MILTON MUNICIPAL UTILITY COMMISSION  
CABELL COUNTY, WEST VIRGINIA

CONTRACT #1 – MORRIS MEMORIAL SANITARY SEWER EXTENSION

ADDENDUM #1

THRASHER PROJECT #020-1526

SHEET No.  
**LS-4**

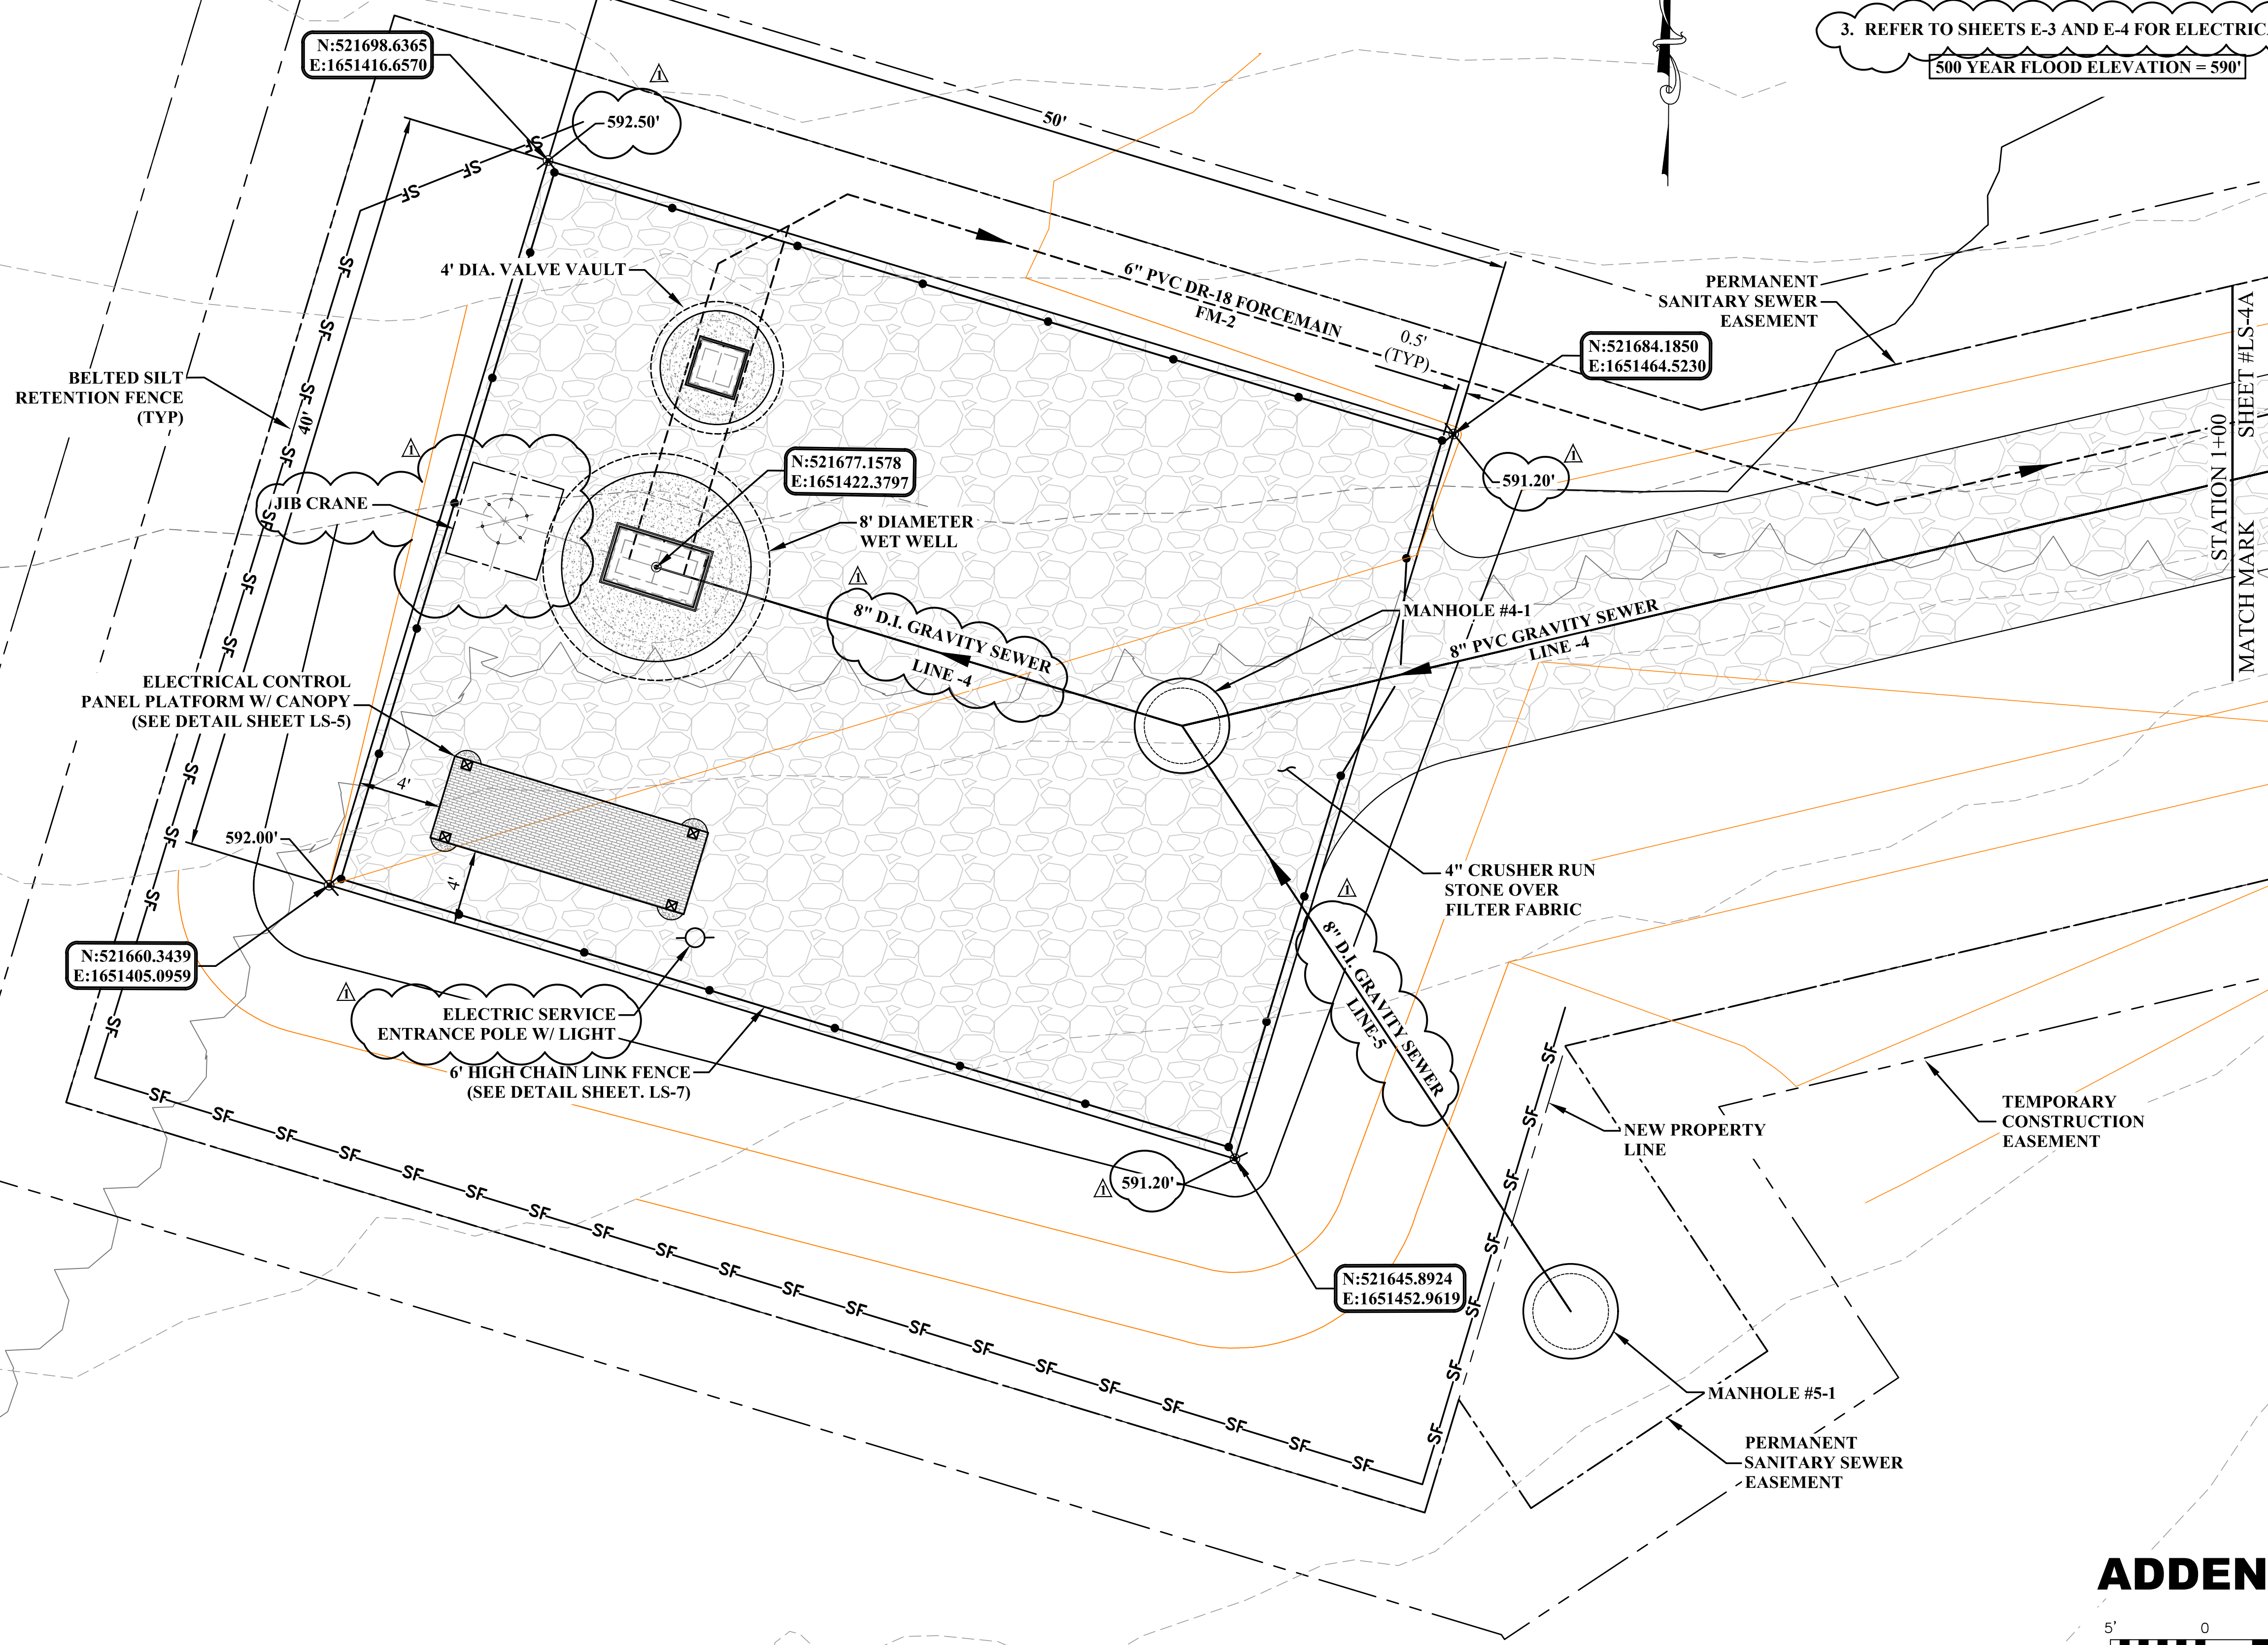
NO.	BY	DATE	DESCRIPTION
1	KMP	1/2022	ADDENDUM 1 - UPDATED PAD ELEVATION - ADDED JIB CRANE

PHASE No. 1  
 CONTRACT No. 1  
 PROJECT No. 020-1526  
 MILTON MUNICIPAL UTILITY COMMISSION  
 CABELL COUNTY, WEST VIRGINIA  
 MORRIS MEMORIAL  
 SANITARY SEWER EXTENSION  
 GRAND PATRICIAN LS PLAN & SECTION  
 SHEET No. **LS-5**

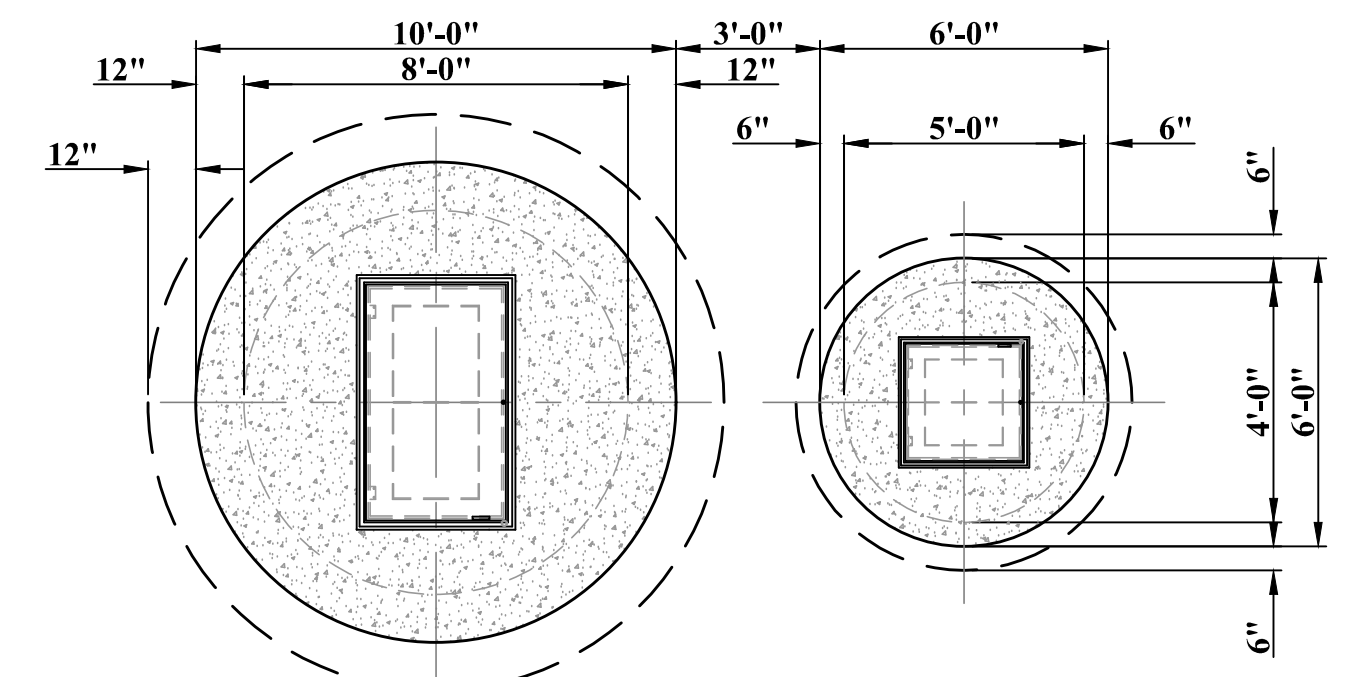
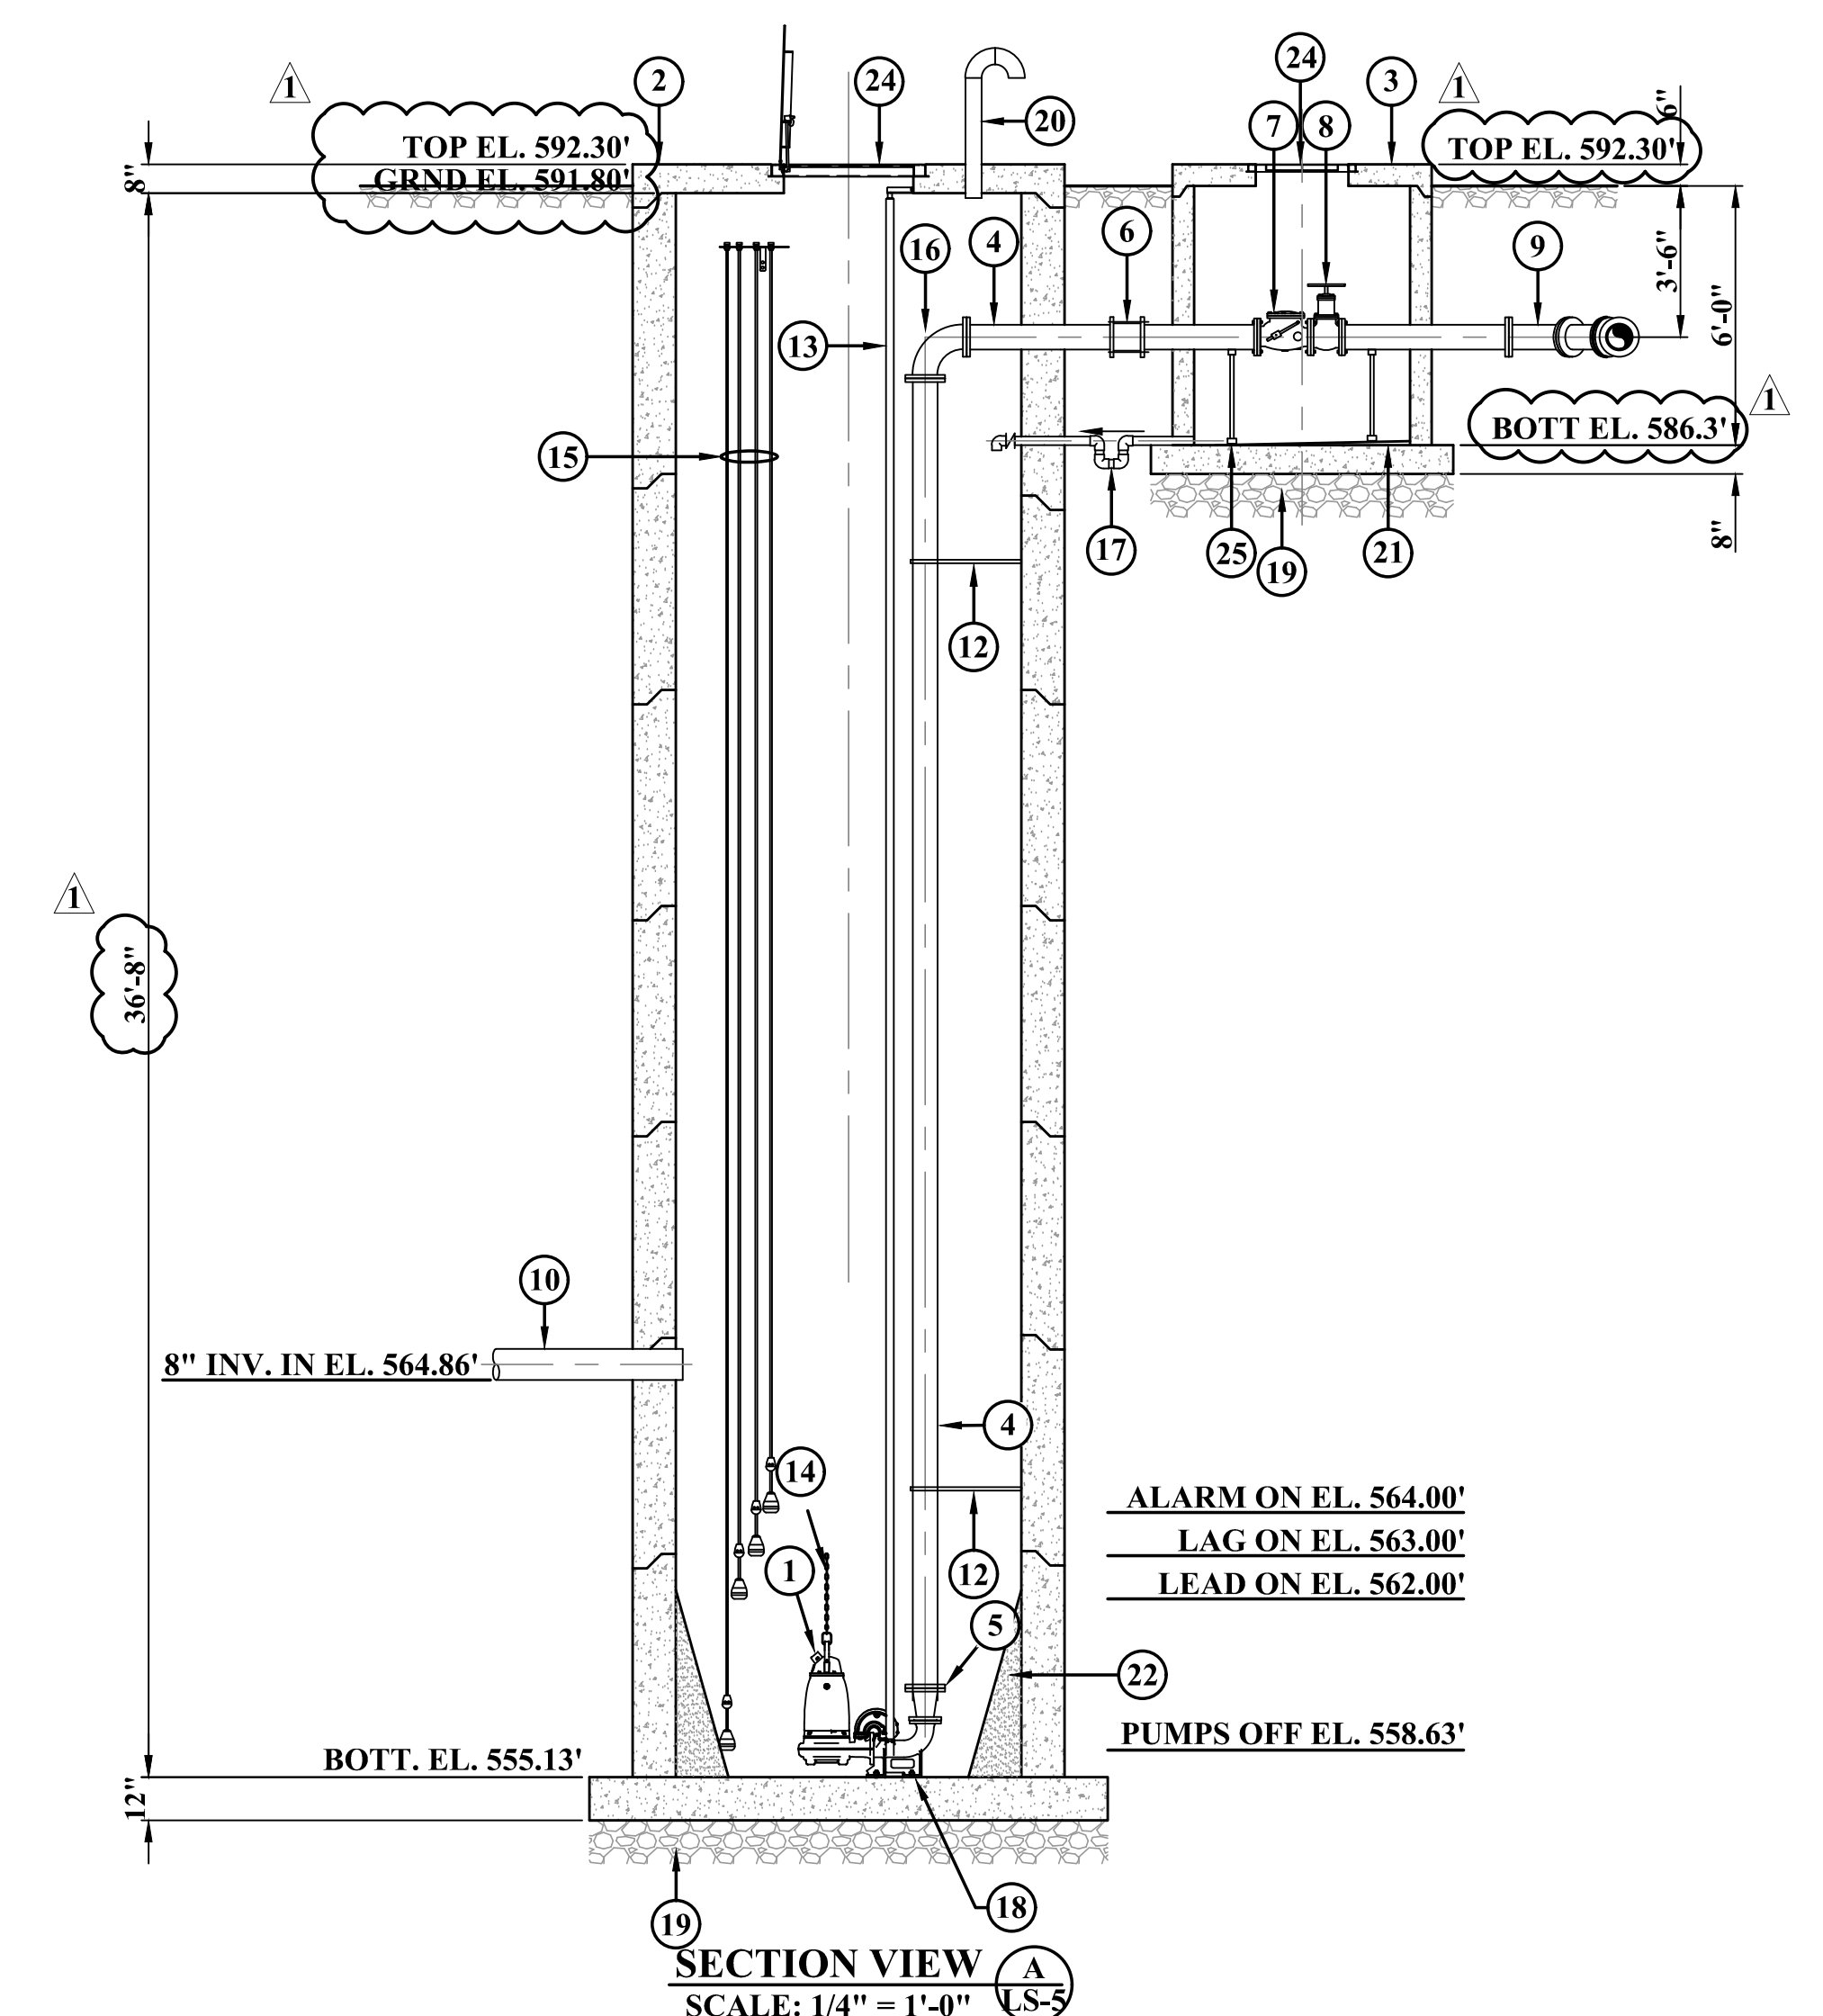
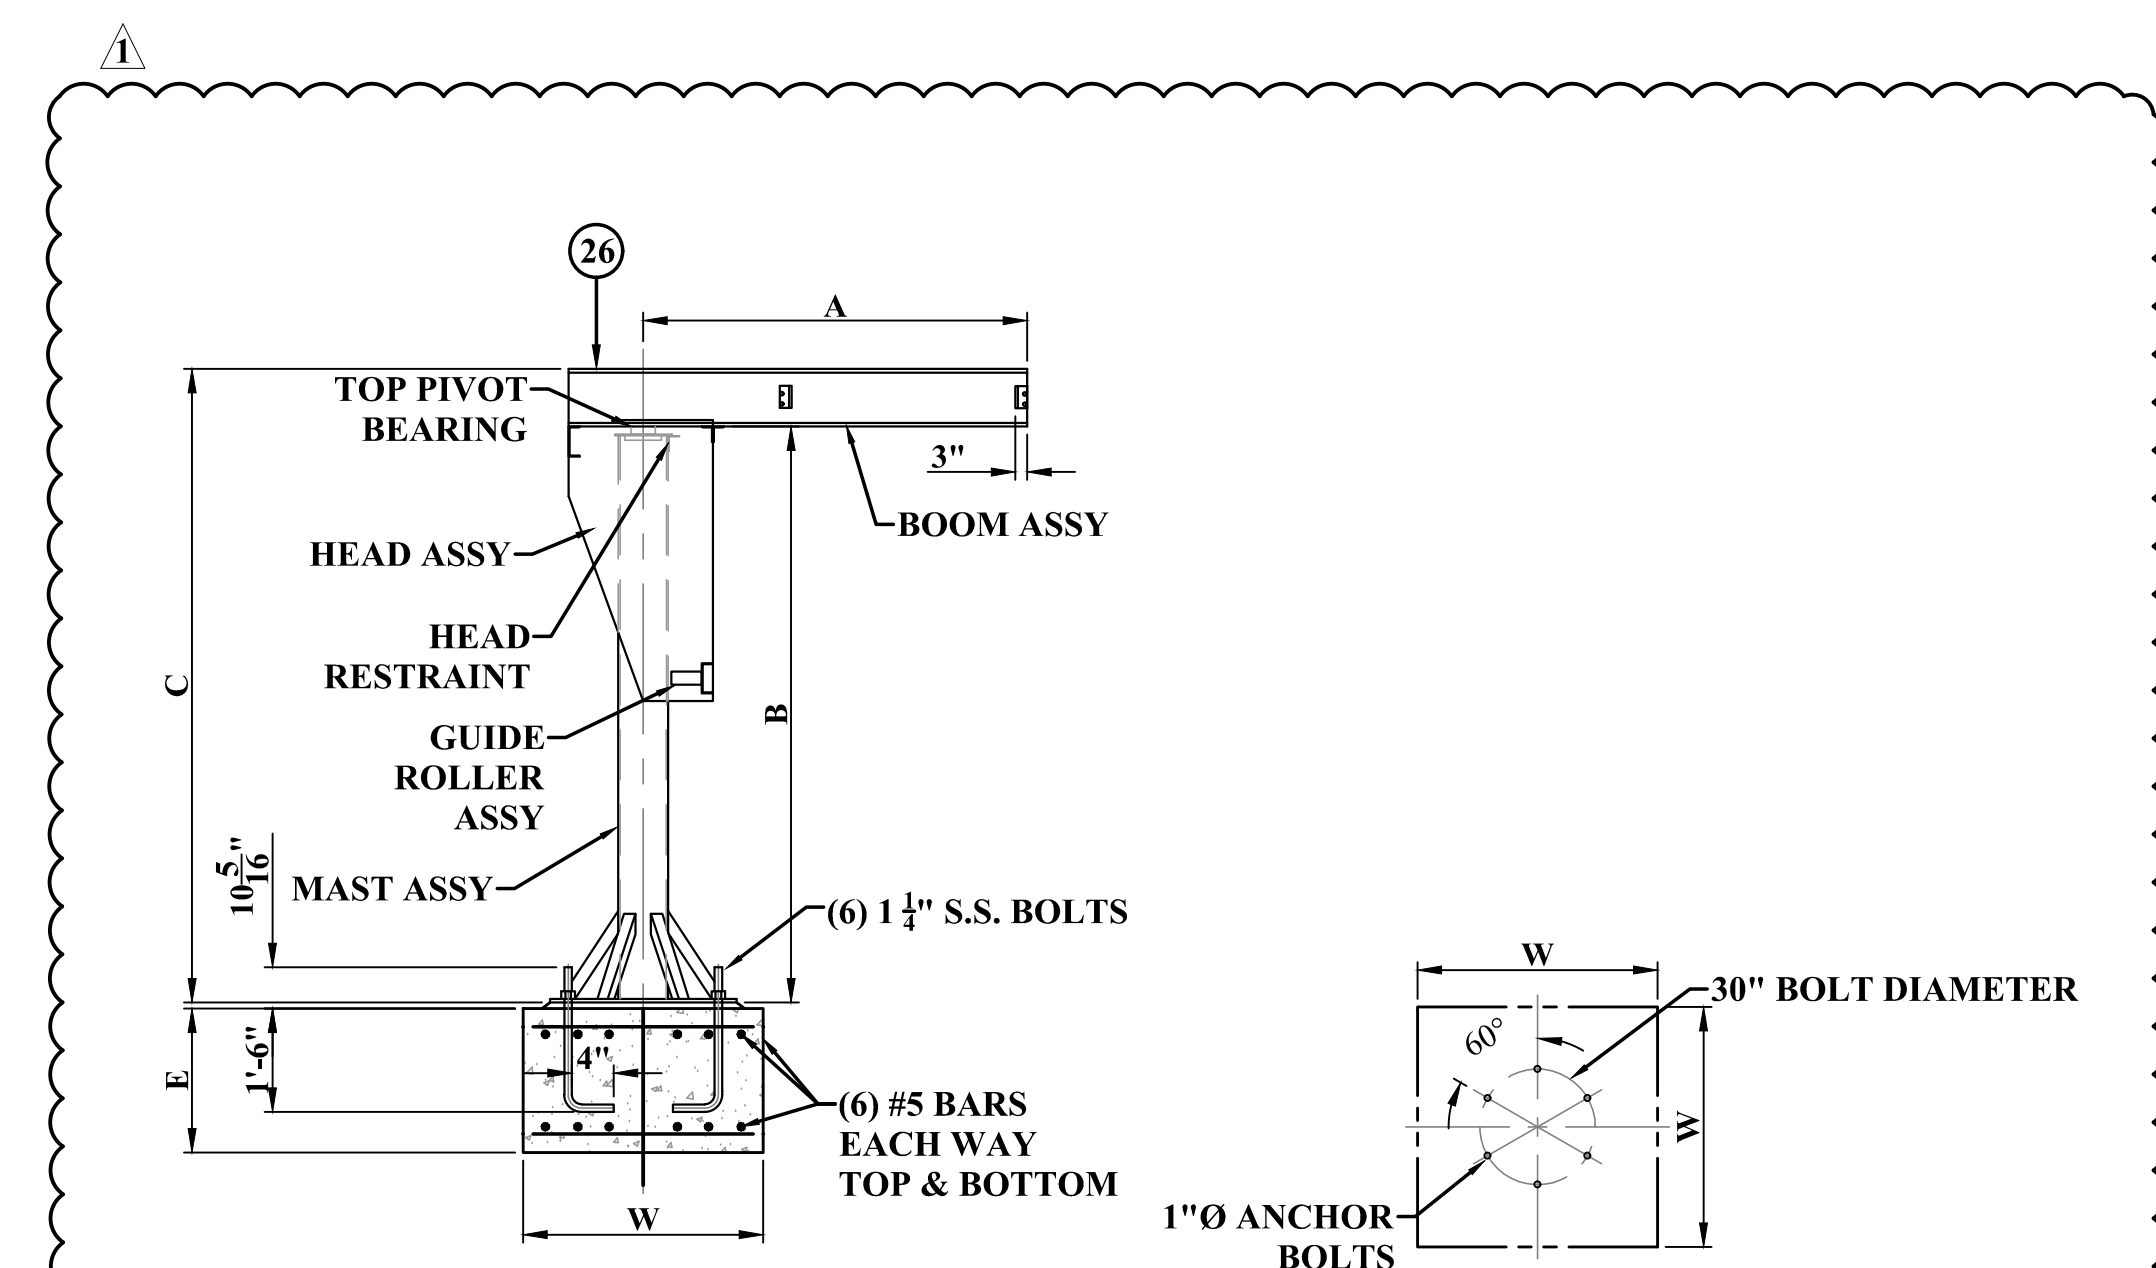
NO.	BY	DATE	DESCRIPTION
1	KMP	1/2022	ADDENDUM 1 - UPDATED ELEVATIONS - ADDED JIB CRANE DETAIL

SHEET No.  
**DET-1**

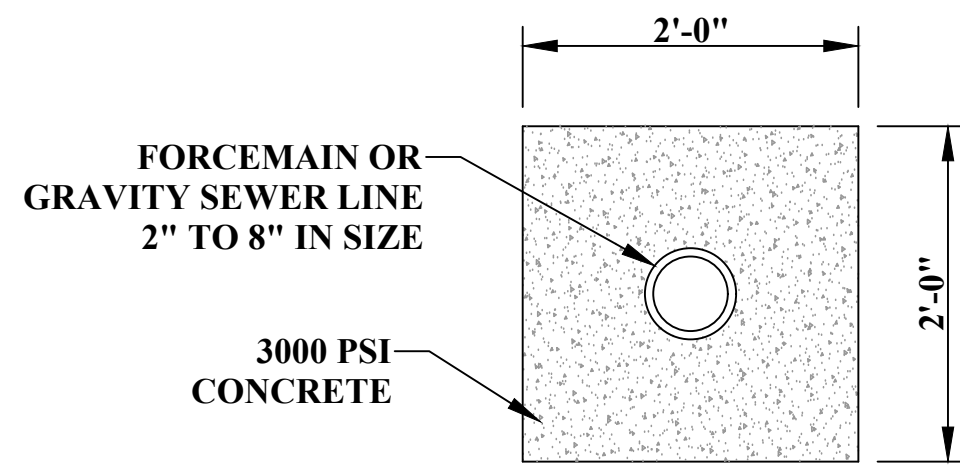
NO.	BY	DATE	DESCRIPTION
1	KMP	1/2022	ADDENDUM 1 - REVISED DETAIL MANHOLE DIAMETER DIMENSIONS
